**Seismic Walkdown Checklist (SWC)**

Equipment ID No.: 1-PP-35W

Project: DC Cook 1 SWEL

Equipment ID No.: 1-PP-4

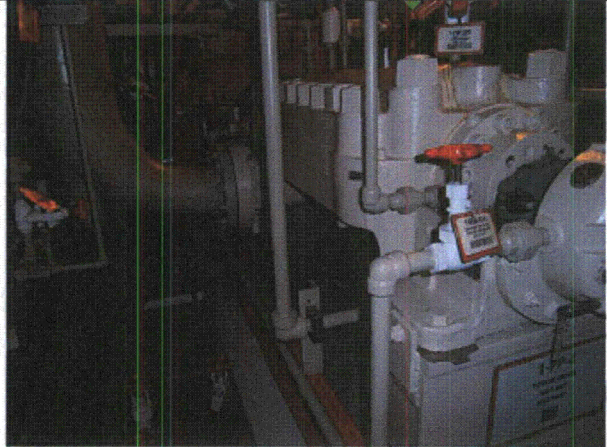
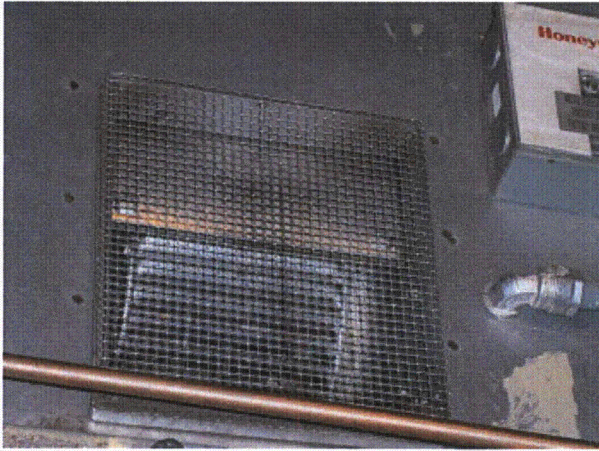
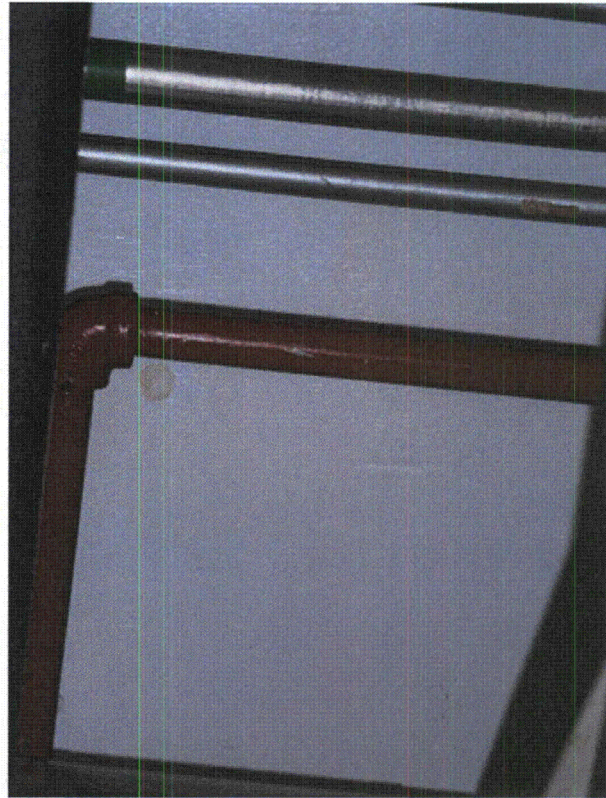
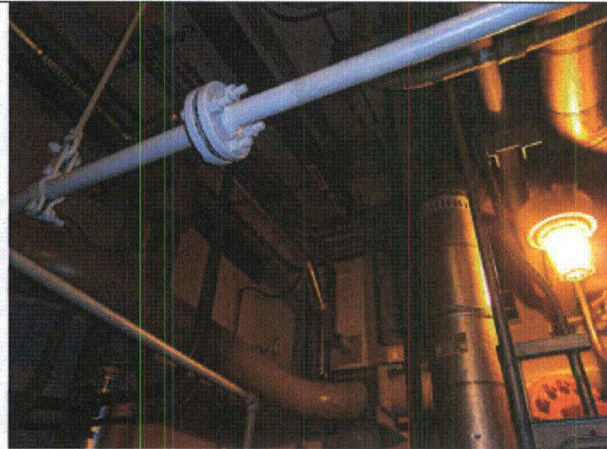
- 2. Is the anchorage free of bent, broken, missing or loose hardware? Yes  
*Can only see 7 out of 8 bolts, 1 bolt not visible because of other equipment in area*

11. Have you looked for and found no adverse seismic conditions that could adversely affect the safety functions of the equipment? No  
*Wet fire protection, rod hung threaded pipe - may develop leakage at threaded joints post seismic event*

Equipment ID No.: 1-SIS

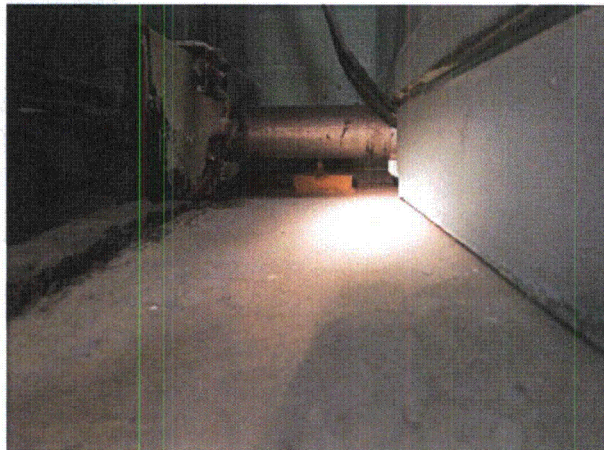
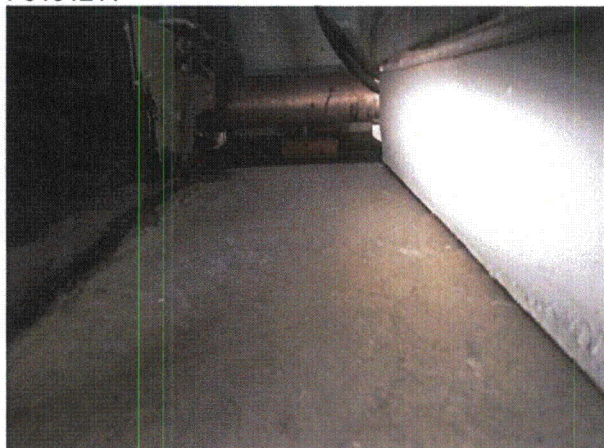
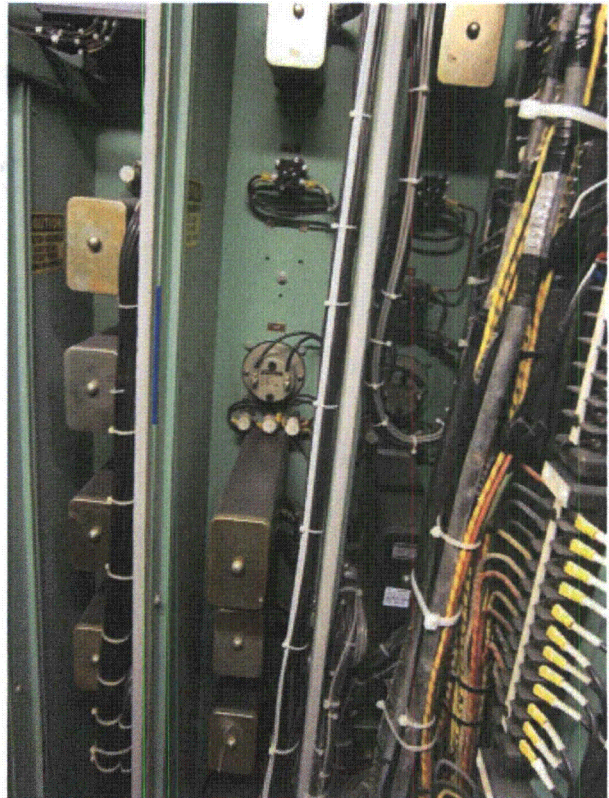
5. Is the anchorage configuration consistent with plant documentation? (Note: This question only applies if the item is one of the 50% for which an anchorage configuration verification is required.) No  
*SQUG SEW package for 1-SIS was incomplete and did not contain the detailed information or sketches of the anchorage configuration. AR 2012-13310, Panel 1-SIS anchorage documentation could not be located was generated as a result*
